SERVICE BULLETIN

DATE: 1 MARCH 1971

KIT INSTALLATION (M50027) – MODIFICATION, TRANSMISSION AND COUPLING FAN ASSEMBLY

Part I of this Service Information Notice lists a procedure for modify the existing 369145610-701 or -703 Transmission and Coupling Fan Assembly to the new 369H5610-705 configuration. Modification including, removal of idler pulley and related components, and installation of a new driver pulley, driven pulley, and timing belt. The new configuration is designed to simplify and improve operation of the oil cooler blower system.

Figure 1. Modification Kit, Timing Belt

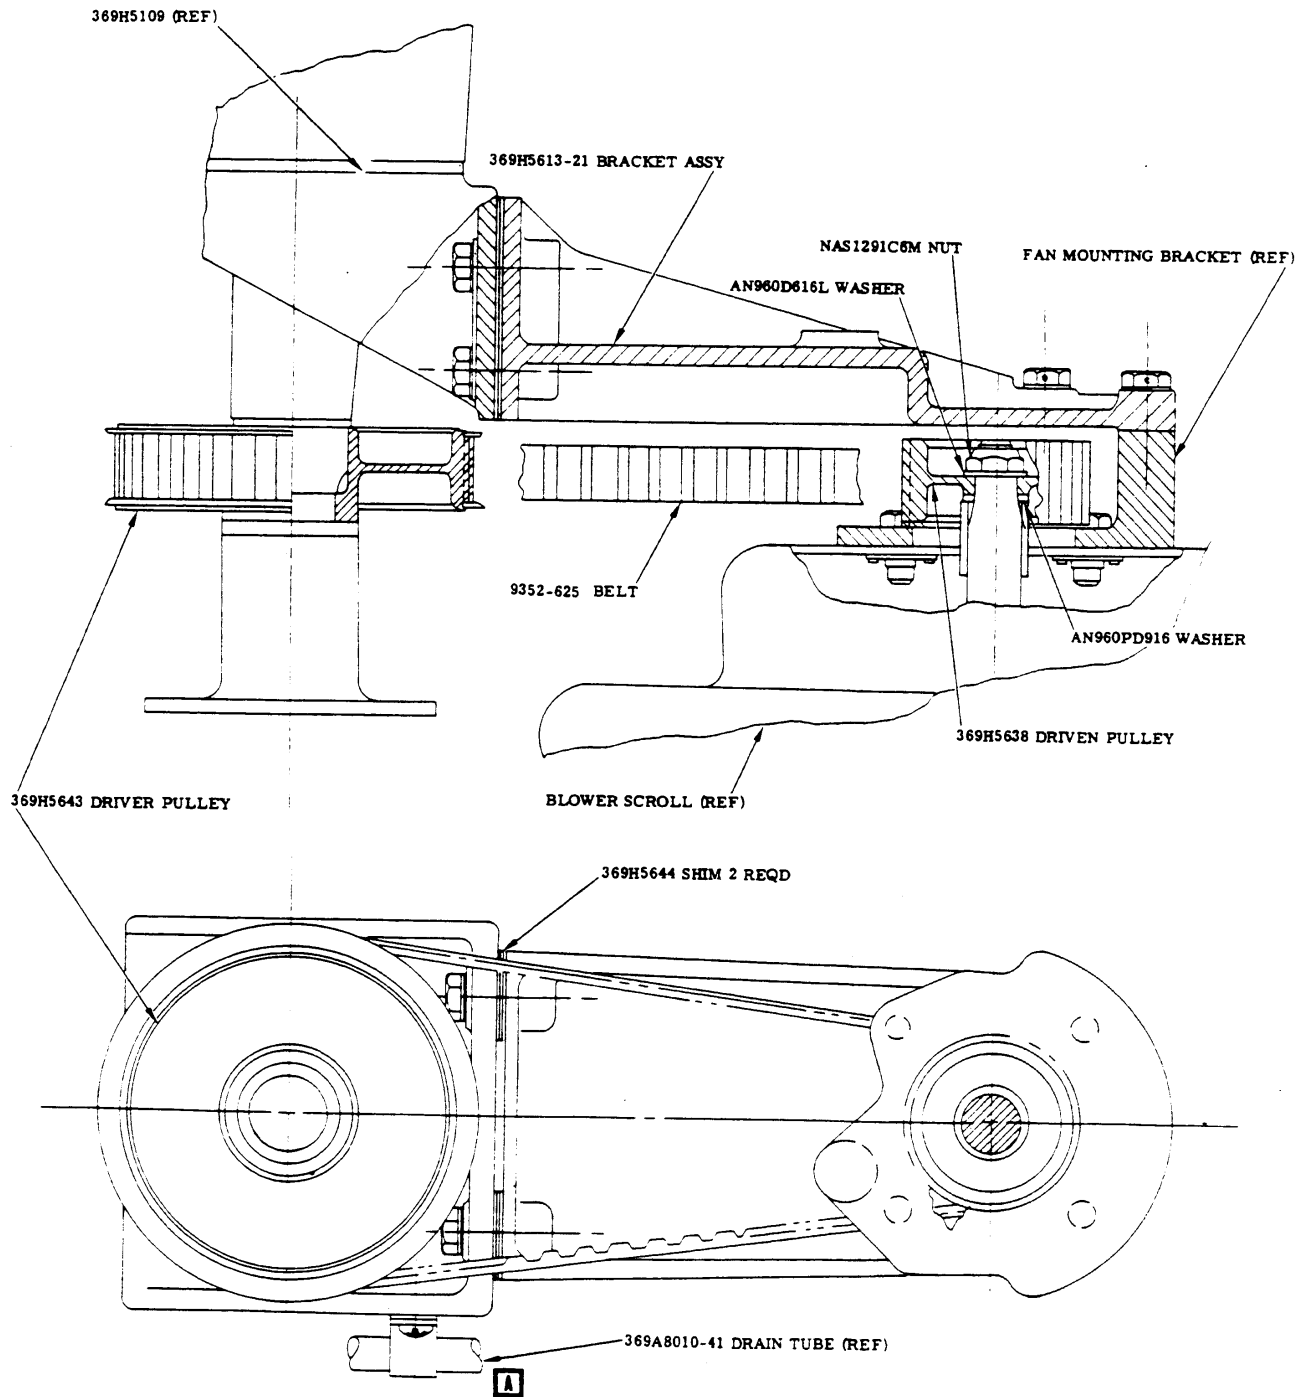
v. Install new oil cooler shields part numbers 369H8308-21 and 369H8303-11 and bend tabs as shown in Figure 1. Secure shields with lock-wire two places as shown. If required, hand form shields to clear structure.

Figure 2. Modification Kit - Fan Assembly, Timing Belt

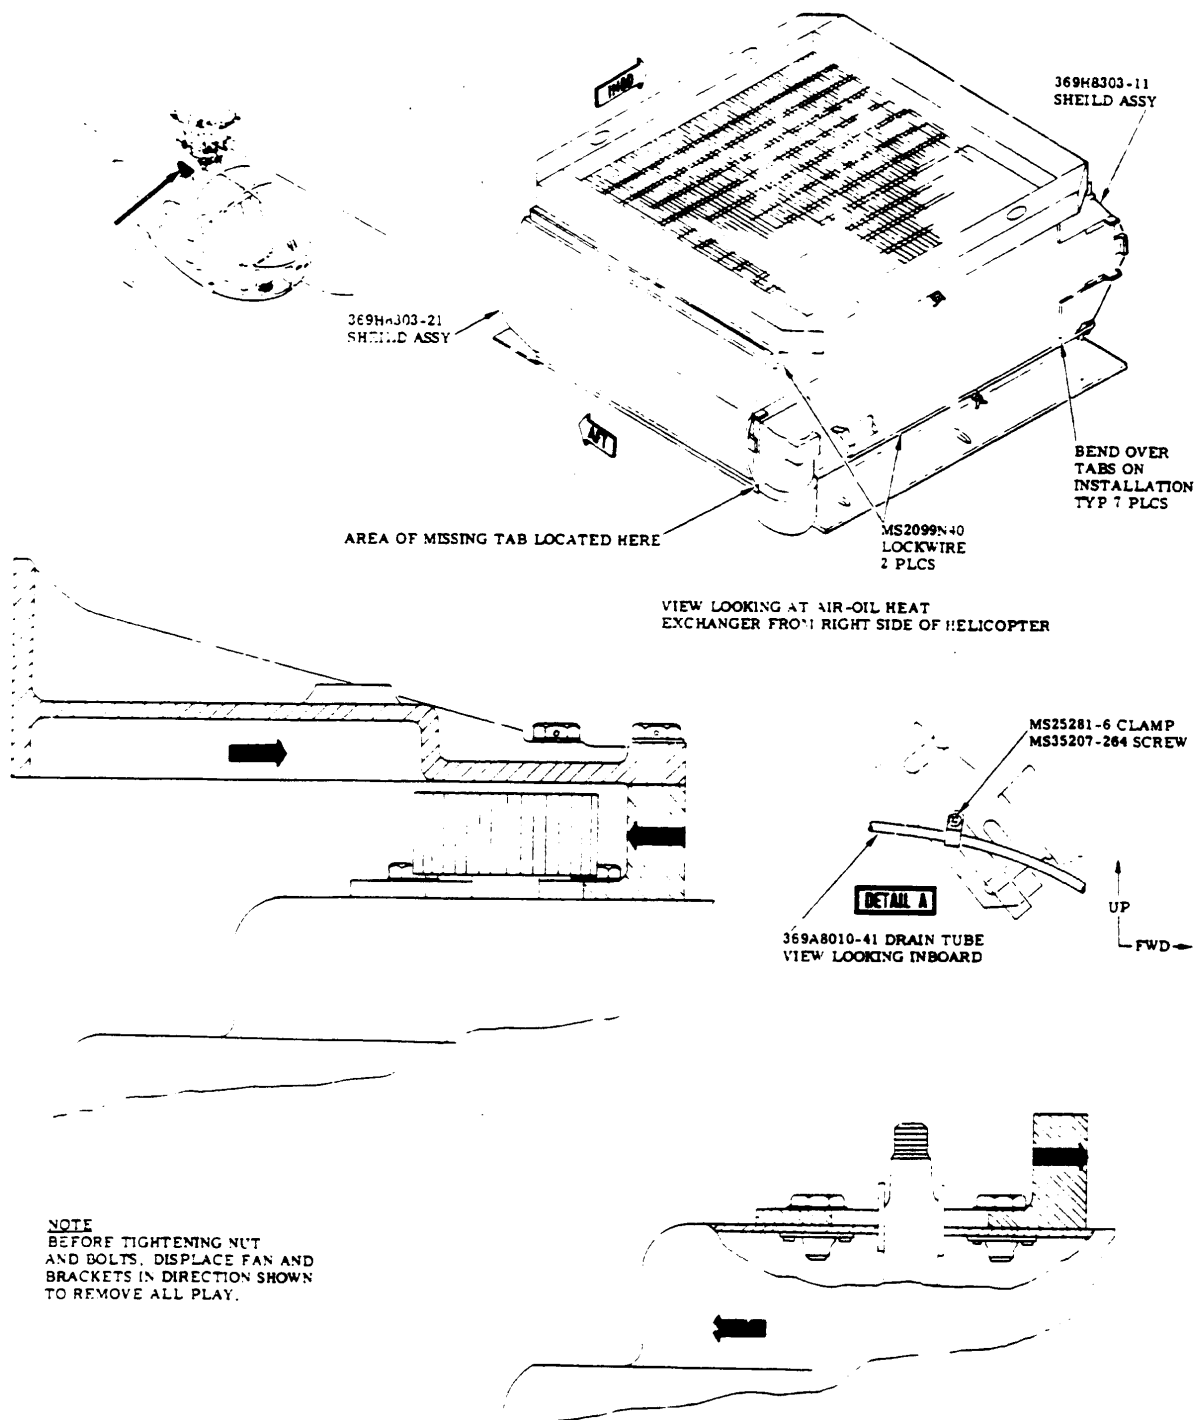
- m. Remove lockwire and break existing torque on fan bracket mounting bolts. Displace fan and bracket fully in directions shown in Figure 2 to remove all play of bolts in bolt holes. Torque fan bracket bolts 60-75 inch-pounds and lockwire bolts in pairs.

o. Position new 9352-625 drive belt on the driven pulley. Install new 369H5613-21 mounting bracket to fan mounting bracket, using existing bolts, washers and spacer. Displace new -21 bracket fully in direction shown in Figure 2, to remove all play of bolts in bolt holes. Torque bolts 60-75 inch-pounds and lockwire bolts in pairs.
